VALUE ENGINEERING WORKSHOP REPORT

Project: SH21/Powers Boulevard & Research Parkway Interchange
Project No. STU 021A-004 (20913)

May 11, 2018

Idea Number: CN-03

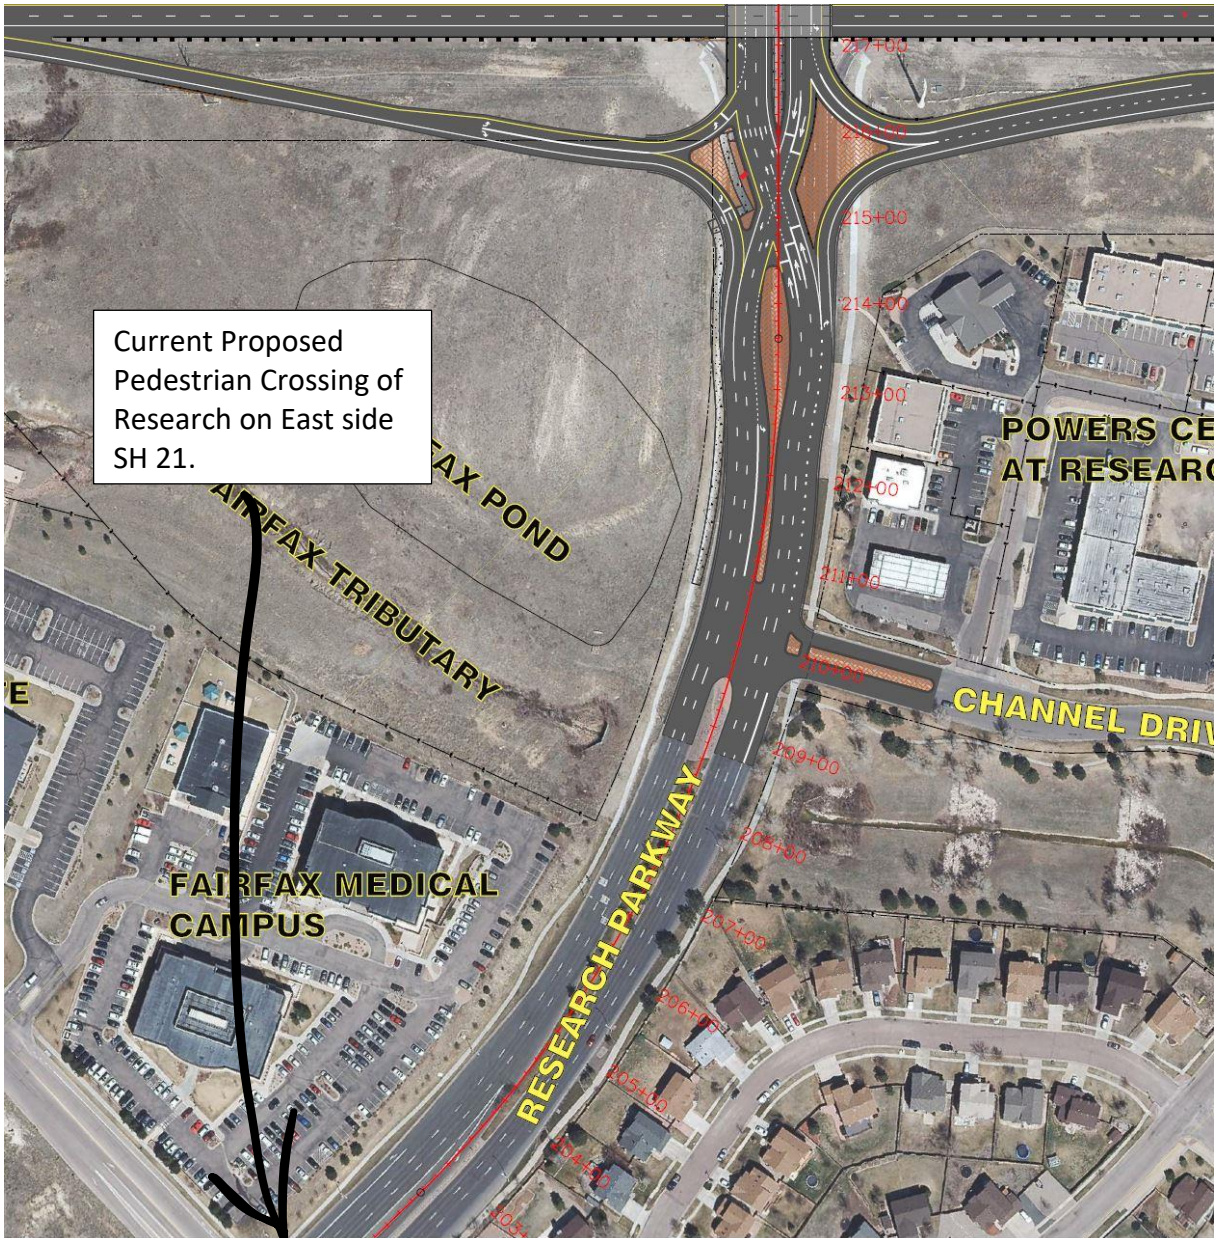
The proposed action is to eliminate the crossing on the south side of Research and funnel pedestrian movements to the north side of Research, under SH 21 and along Research to Scarborough. At Scarborough, the signalized intersection will provide protection to allow pedestrian crossing across Research. The concern is pedestrian traffic desiring to access Powers Center at Research Shopping Plaza, Fairfax Ridge neighborhood, Wolf Ranch on the south side of Research and amenities. Providing a signal control at Ramp C timed with the intersection would allow pedestrian crossing to the south side of Research without navigating to Scarborough and backtracking.

Impacts to the current design would include moving the eastbound stop bars back, revising the drainage plan at the island to avoid inlet & manhole conflicts, including signal and pedestrian poles at Ramp C to be timed with the intersection & additional ADA accommodations.

Idea Number: CN-03

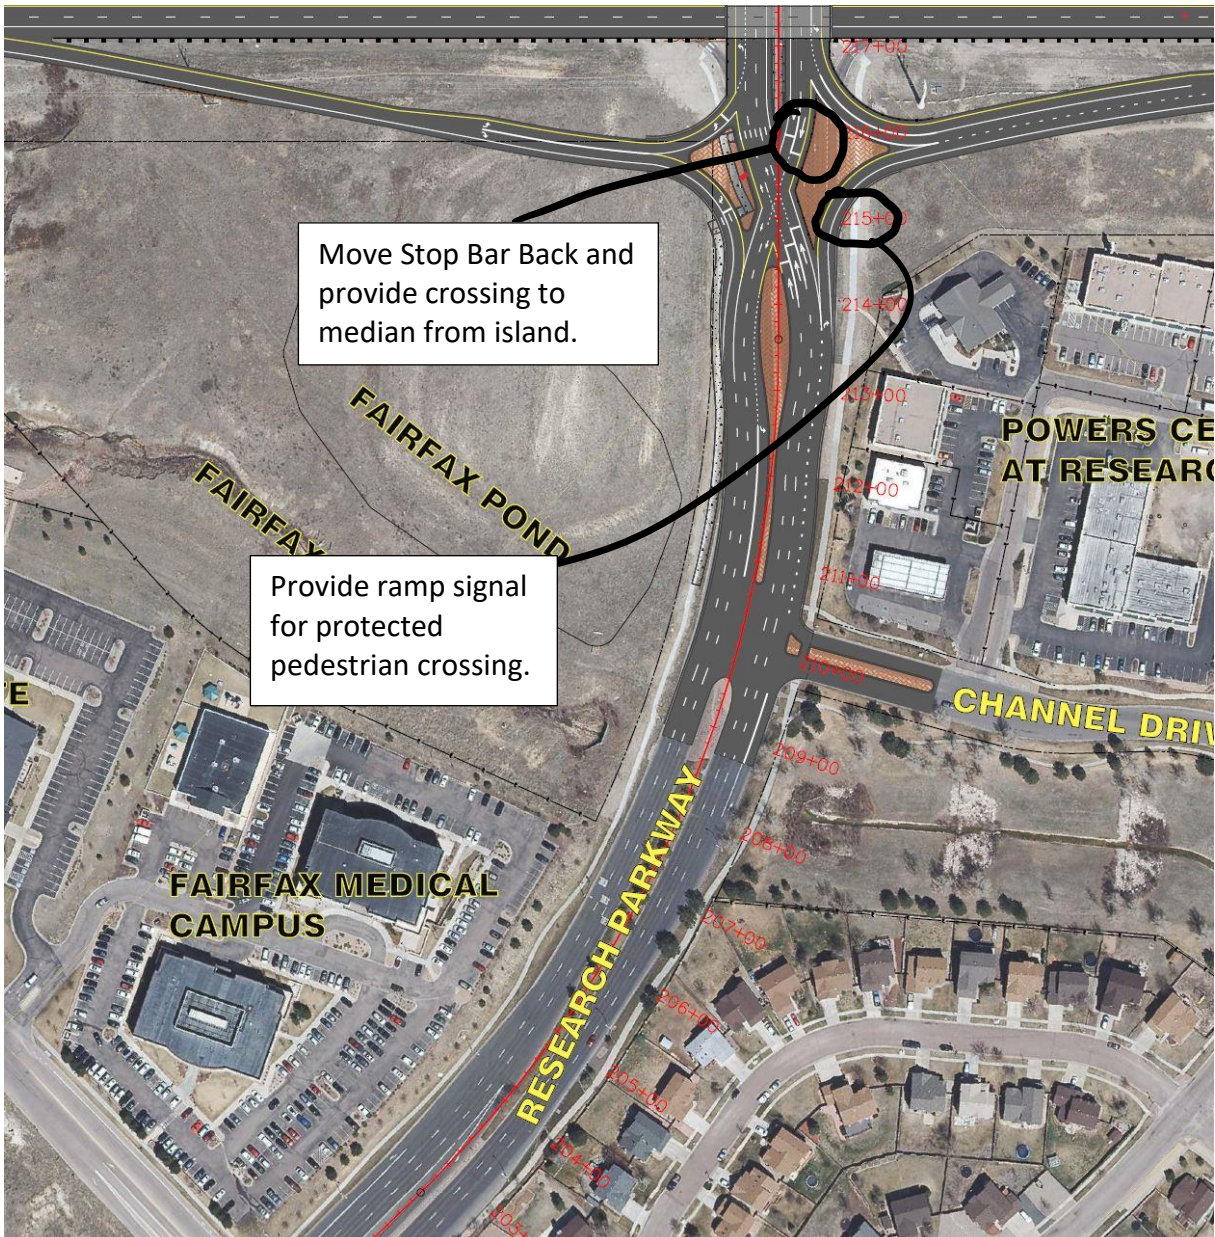
Maintain the sidewalk on the southwest quadrant and provide a protected crossing across Ramp C approximate station 520+20 and protected crossing of Research to the median sidewalk approximately station 216+00.

The concept is to provide neighborhood connectivity on the south side of the interchange. Neighborhoods, shopping center & park are located on the south side as well as on the north side. This eliminates the “back tracking” from Scarborough Drive to the neighborhood on the southwest quadrant as well as Powers Center at Research Shopping Center.

Idea Number: MD-01

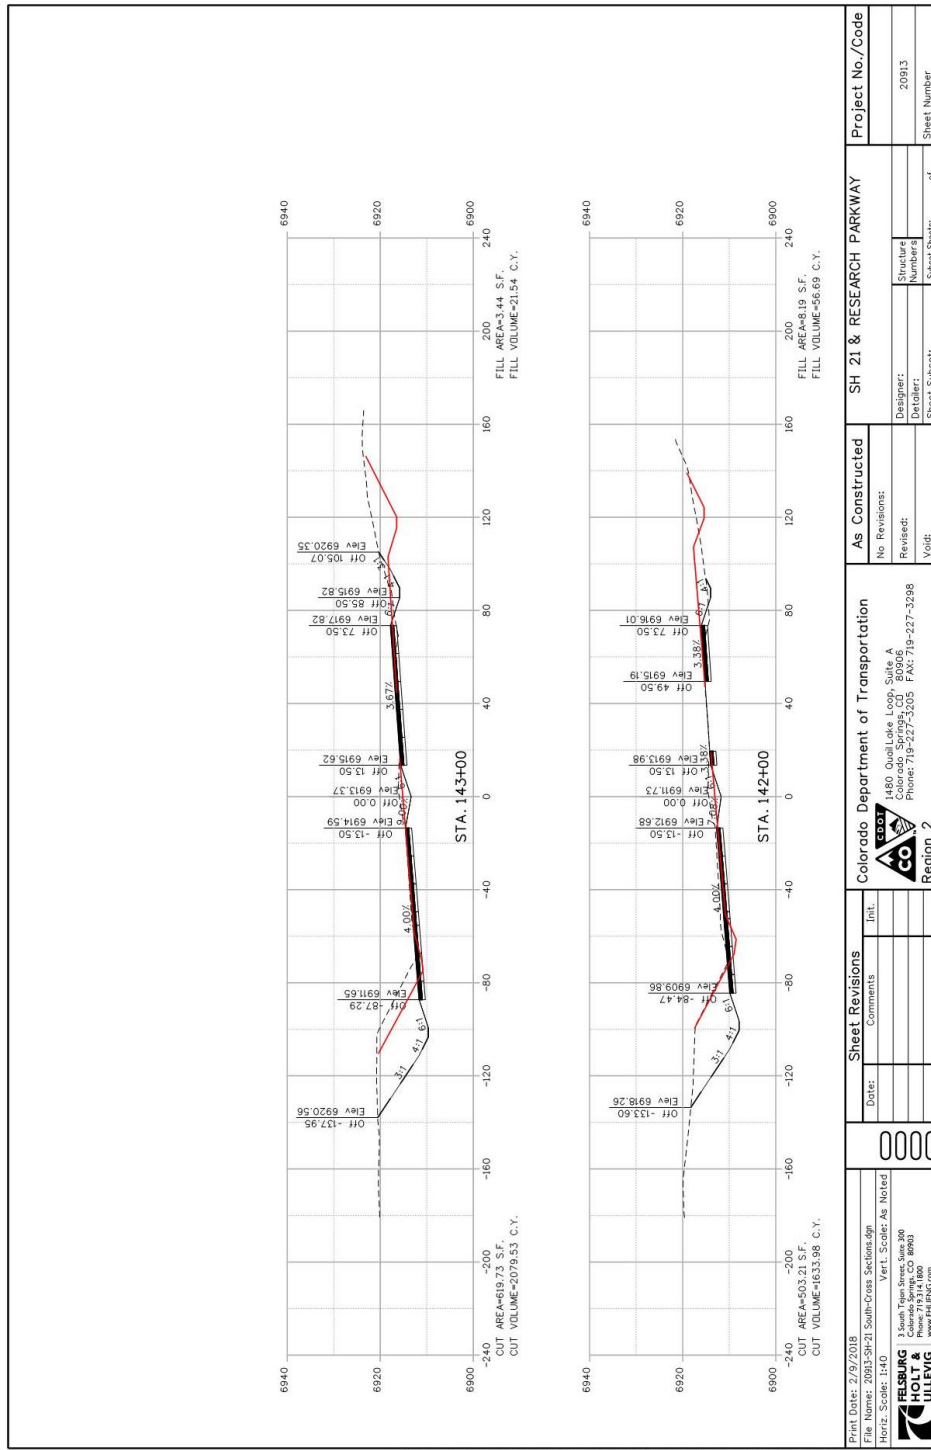
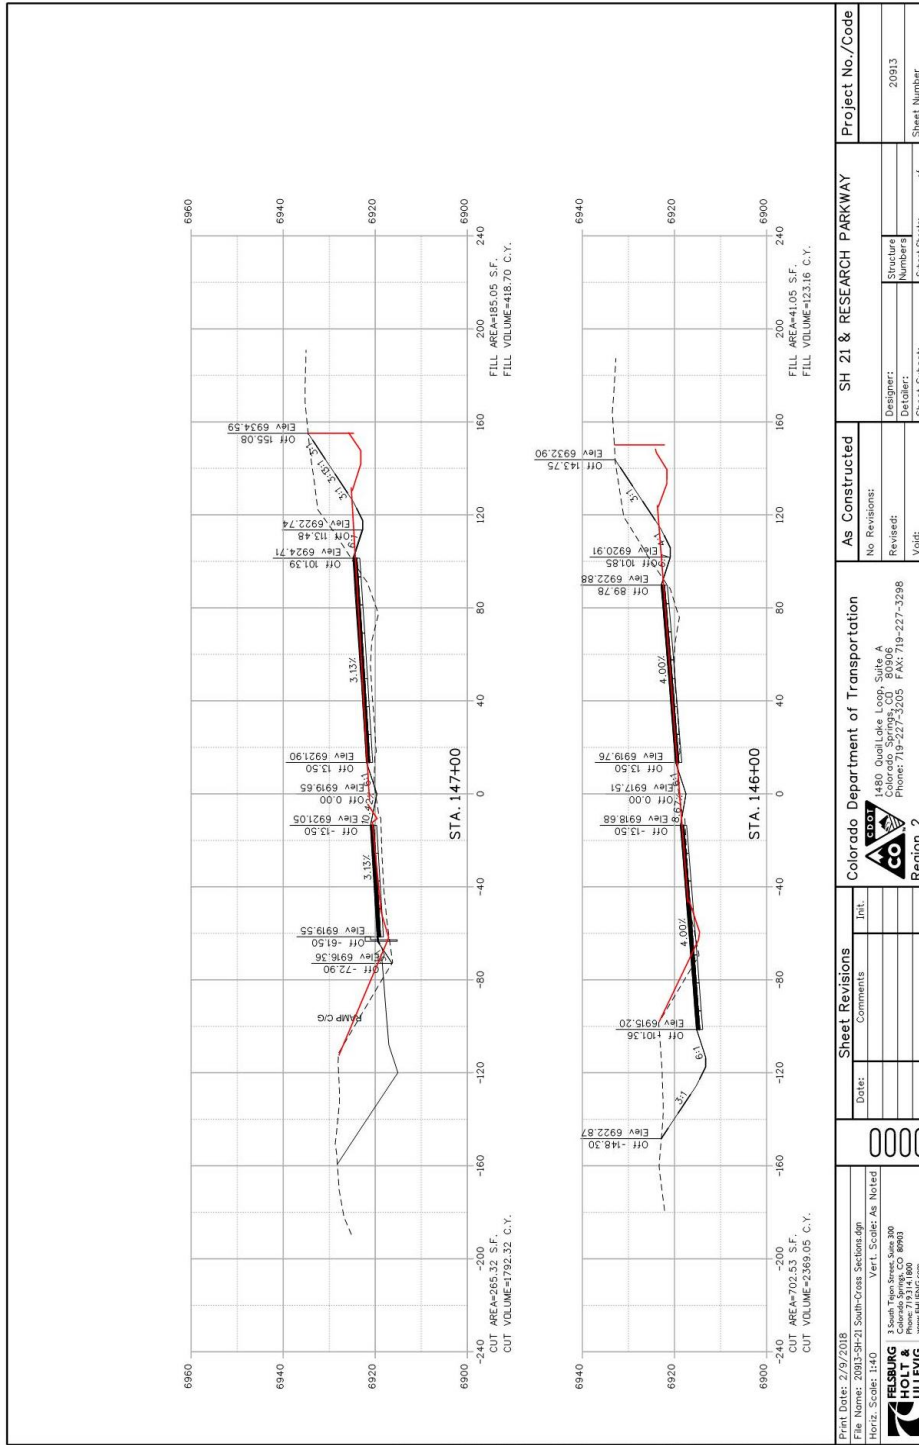
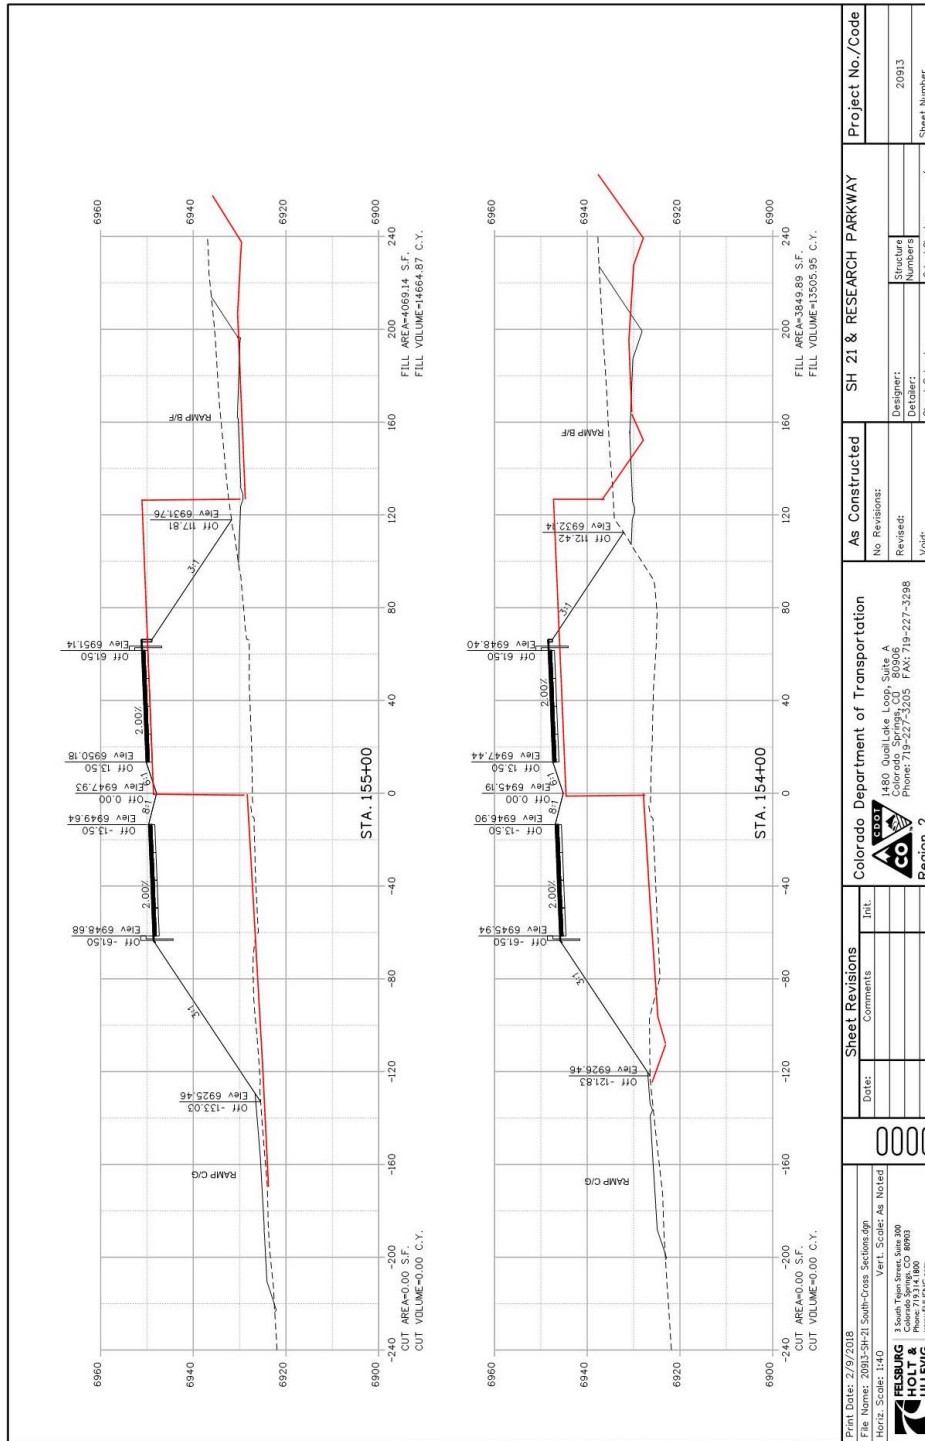
- Additional wall cost will be introduced to the project.
- May introduce additional right-of-way (in lieu of walls).
- Will introduce additional guardrail.
- Surface drainage may be more difficult to deal with in the median of Powers.
- Additional curves would be required from the Cottonwood Bridge to the north tie-in to accommodate shift.

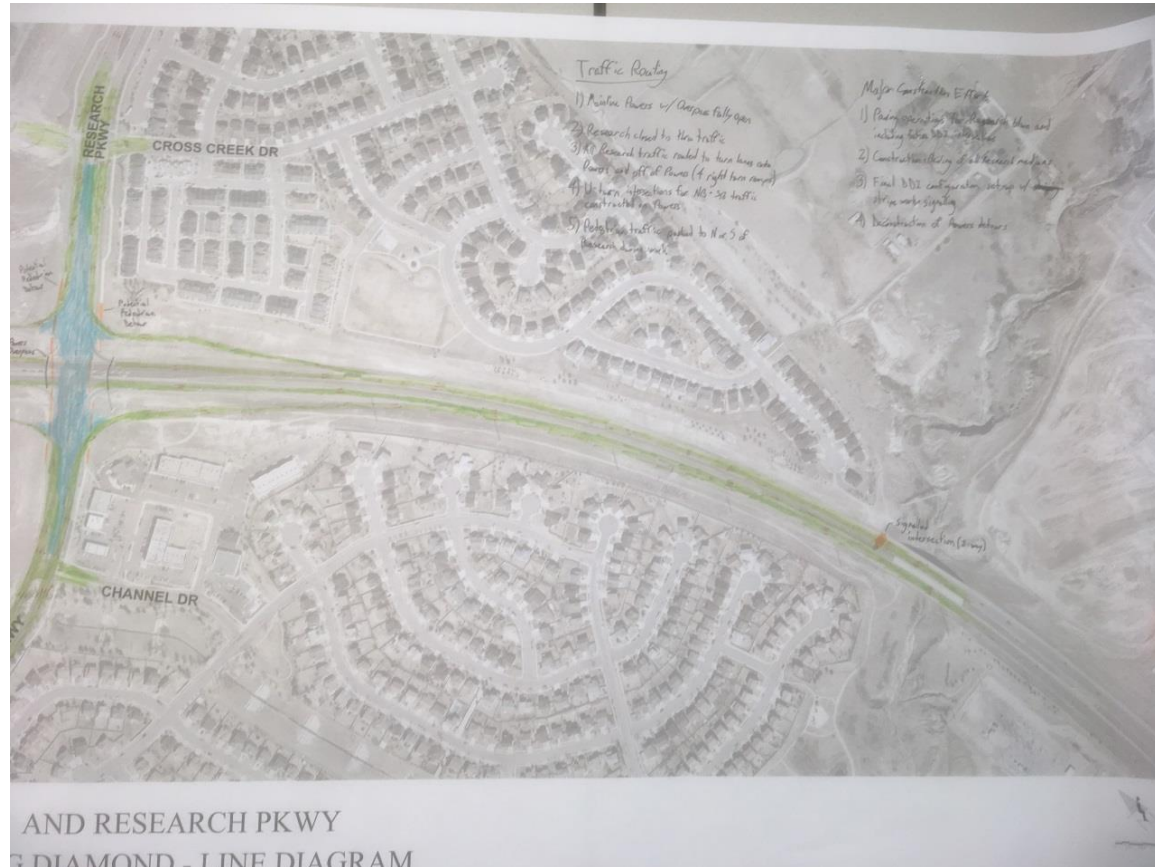
Minimizing disruption to the traveling public during construction is going to be difficult at this location. Closing through traffic on Research over Powers during construction will allow the contractor to construct the largest element of the project without continually shifting traffic.

A temporary pedestrian path could be constructed through the work zone to keep access across powers open. Or, the contractor could hire a shuttle service to drive pedestrians around the work zone.

The Contractor could potentially set up a temporary light at Channel Drive to allow construction traffic out of the pond site to haul material east on Research to place fill on Powers.

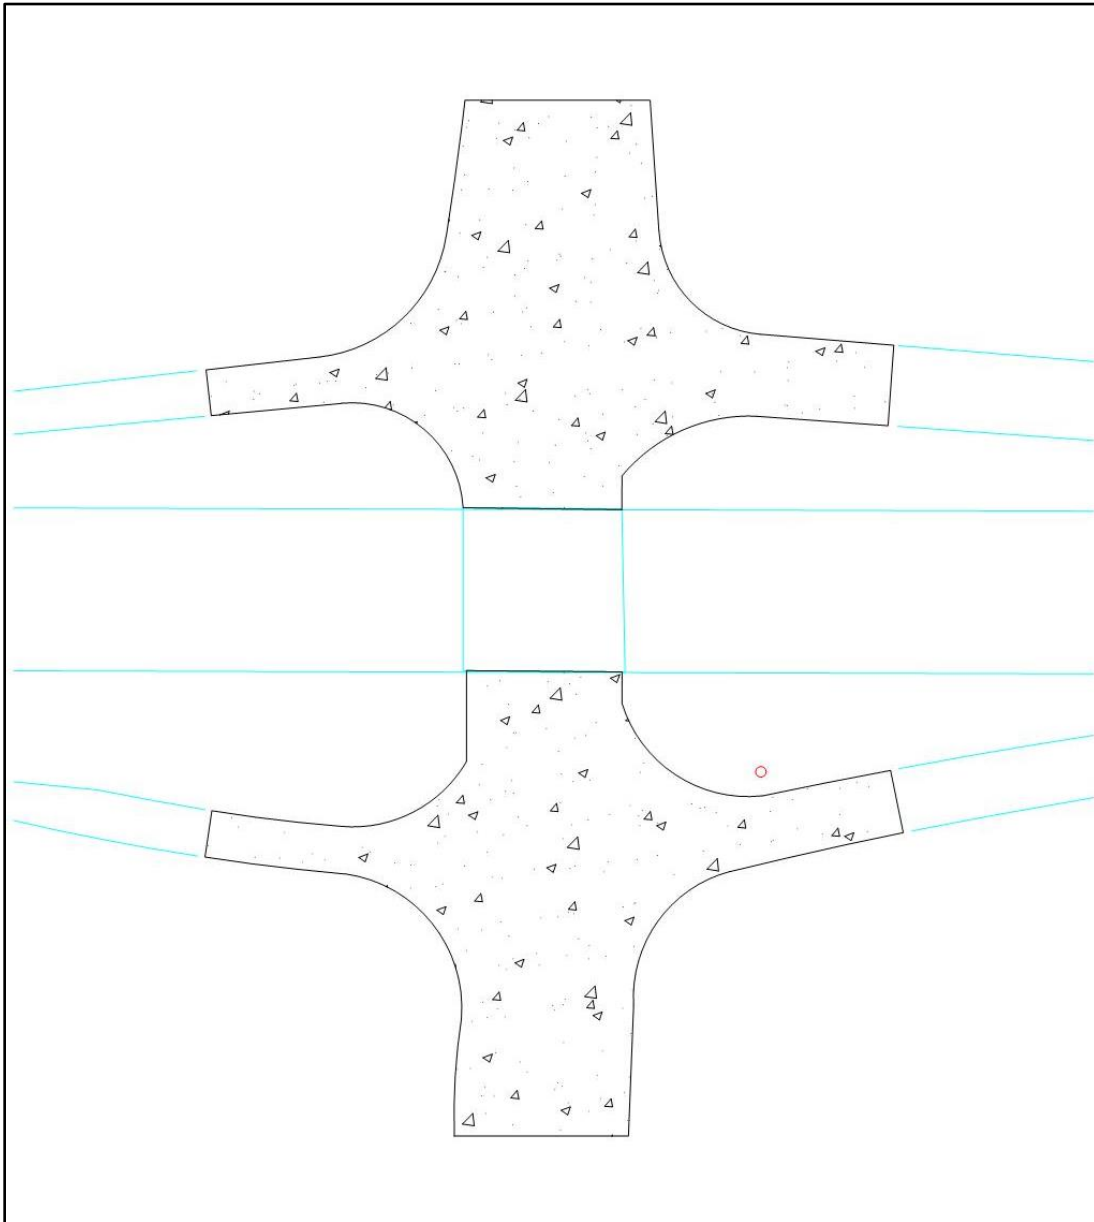
Replace HMA surfacing with concrete through the interchange on Research Parkway.

- Accommodates traffic through the intersections as needed (for Powers) during construction.
- Use of pinned curb (CDOT Type 4) for raised islands eliminates need for removals during later phases. This may also reduce work zone and speed up construction for median curb and gutter.)
- Longer life for the surfacing.
- Reduces amount of base material and reduces overall pavement section. (Thickness)

- Introduces a seam between HMA and concrete pavement on entrance/exit to intersections (differential settlement and jointing of medians).
- Less flexibility in time and traffic control for initial construction.
- Jointing to follow lane lines becomes 'interesting'.
